PLANNING UNIT REPORT
DEPARTMENT OF PLANNING AND DEVELOPMENT
of October 31, 2006

RE: I.D. # 04597: Zoning Map Amendment I.D. 3226 To Rezone 1516 – 1610 Gilson Street & 1507 Beld Street from C3 (Highway Commercial District) to PUD-GDP-SIP

SUBJECT: 1610 Gilson Street Demolition/Rezoning

SUBJECT: 1610 Gilson Street – Rezoning – C3 to PUD (GDP-SIP) - 13 Unit Apartments, w/
5243 SF of Commercial and Retail

Atch. Exhibit page “LS-1” [9/6/2006], notated with approximate amenity location

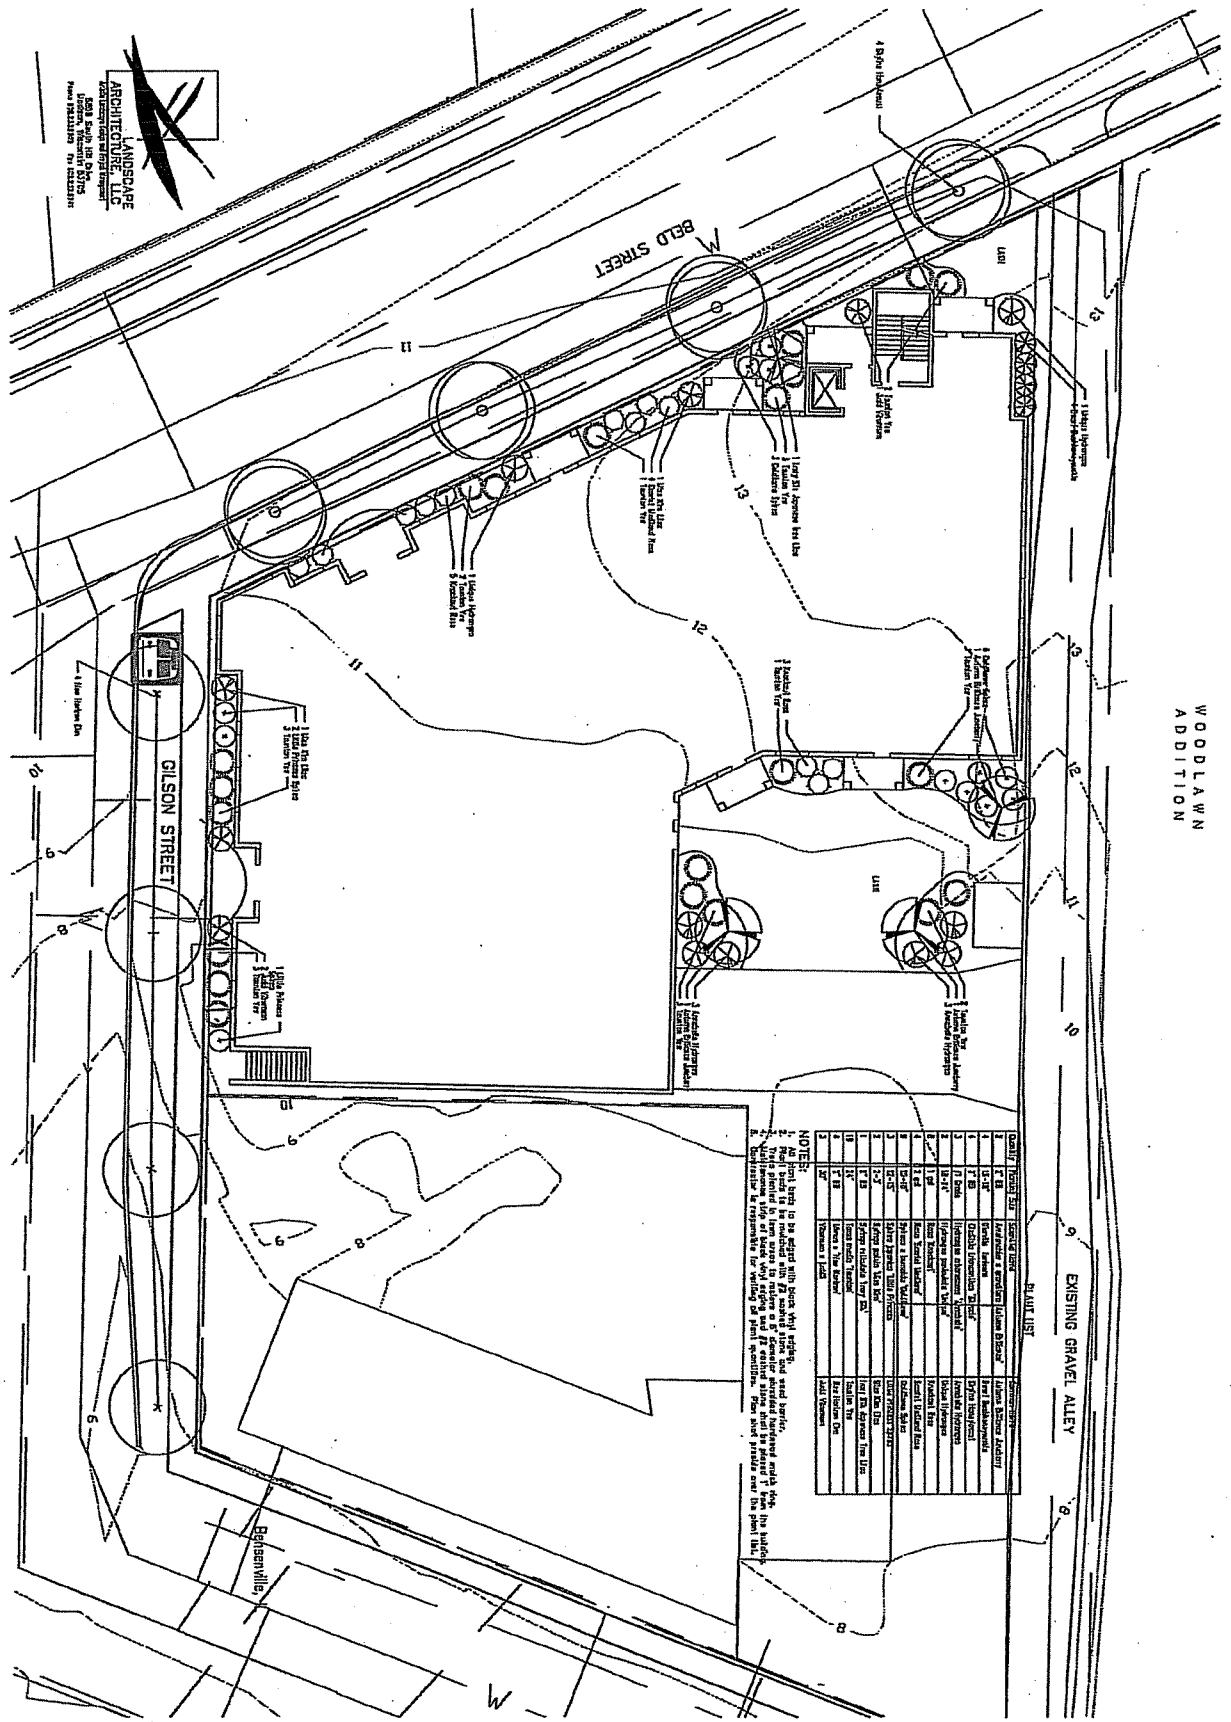
1. The applicant shall install a concrete passenger boarding pad on the north side of Gilson Street, approximately ten feet east of curb ramp along the east side of the Beld Street intersection. The concrete pad shall occupy the full distance of the terrace, measure 6 feet in width parallel to the street, and lie flush between the sidewalk and the top of curb.
2. The applicant shall include the location of this passenger amenity on the final documents filed with their permit application so that Metro Transit may review and approve the design.

1610 GILSON STREET - EXHIBIT 1

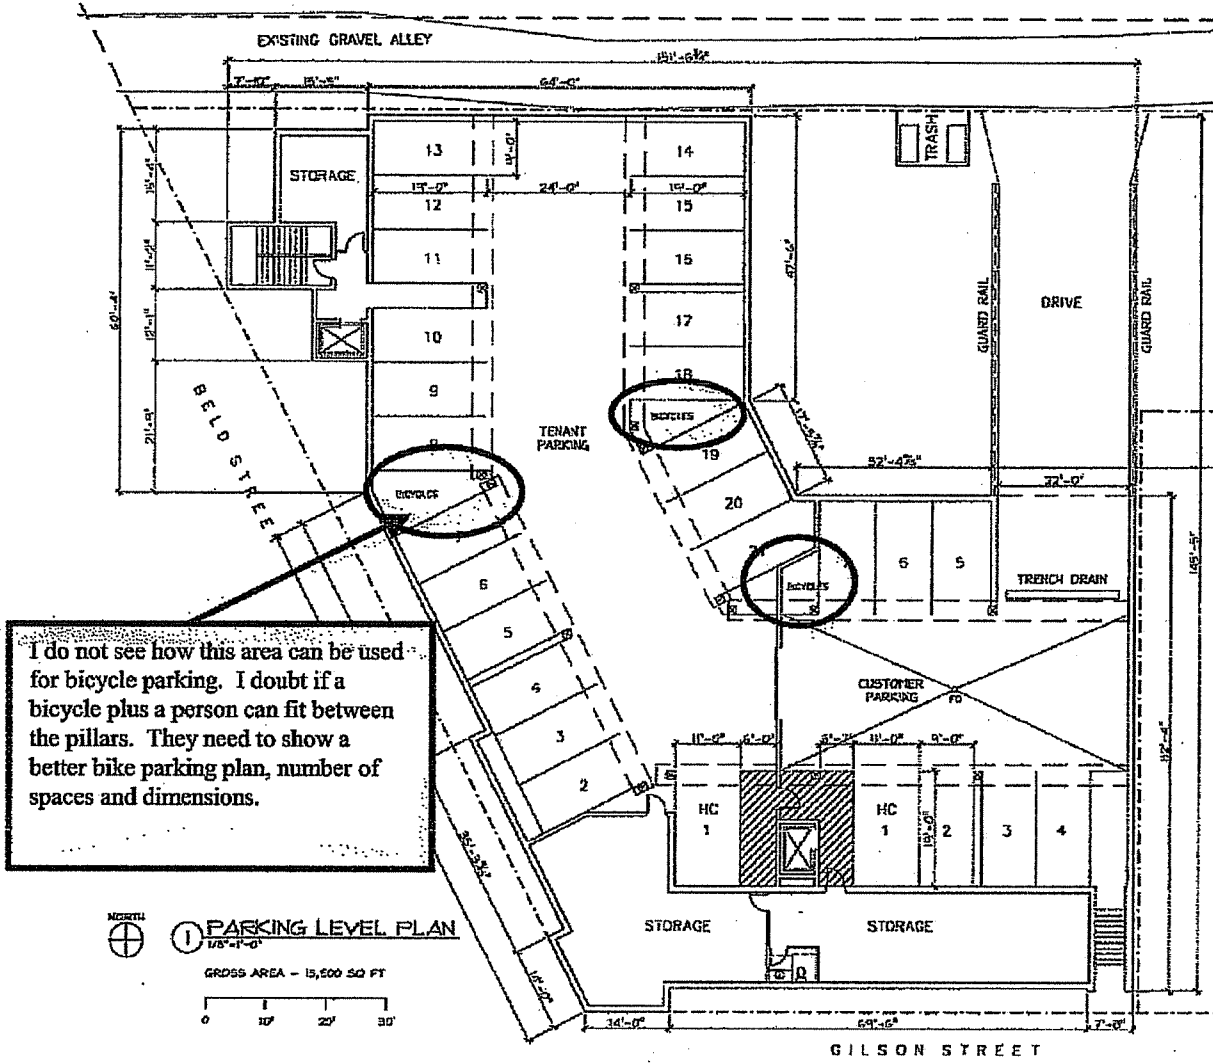
I do not see how this area can be used for bicycle parking. I doubt if a bicycle plus a person can fit between the pillars. They need to show a better bike parking plan, number of spaces and dimensions.

1610 GILSON STREET - EXHIBIT 2

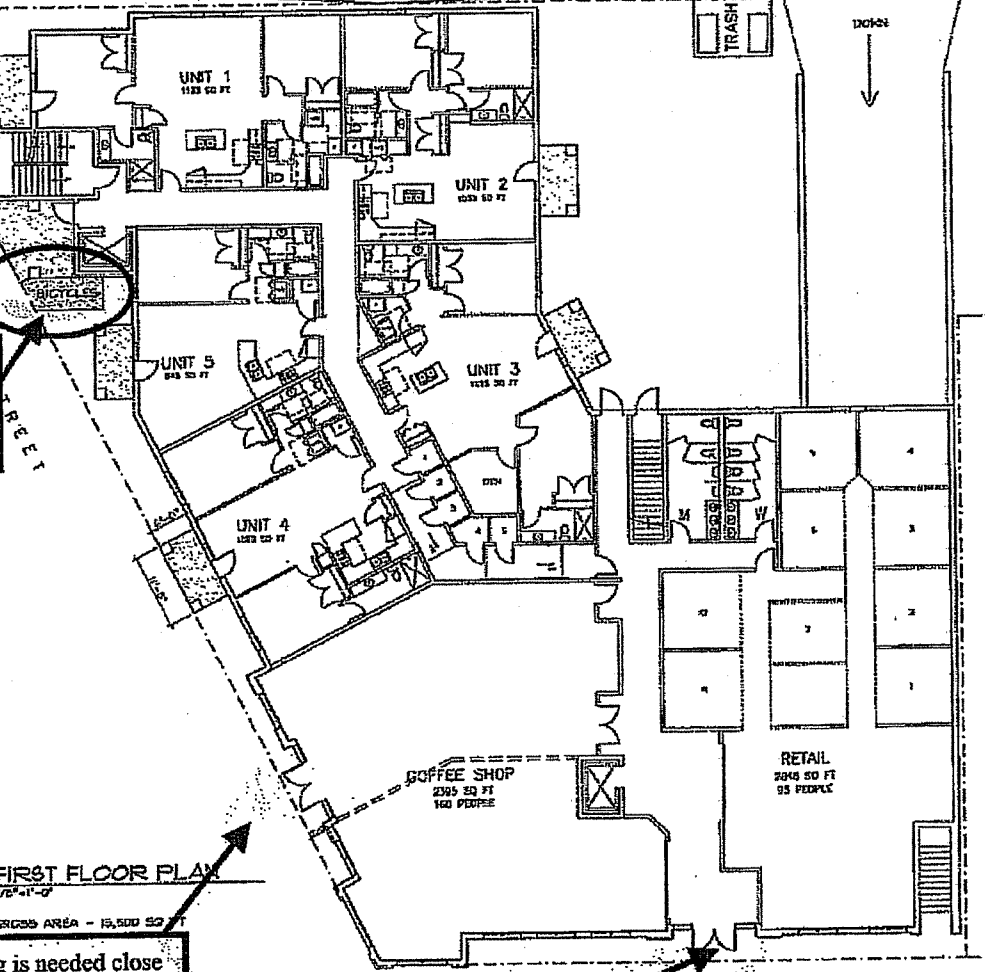
Is this a building entrance (where are the doors)? How do you access units from the street? If this is not an entrance, then this is not a good location for bicycle parking

Need dimensions and number of bicycle spaces

Bicycle parking is needed close to the entrances of each retail store. I suspect the southern entrance is the main building entrance to the apartments, meeting space, etc. as well, so this is where the bike parking is needed, as opposed to location indicated above.
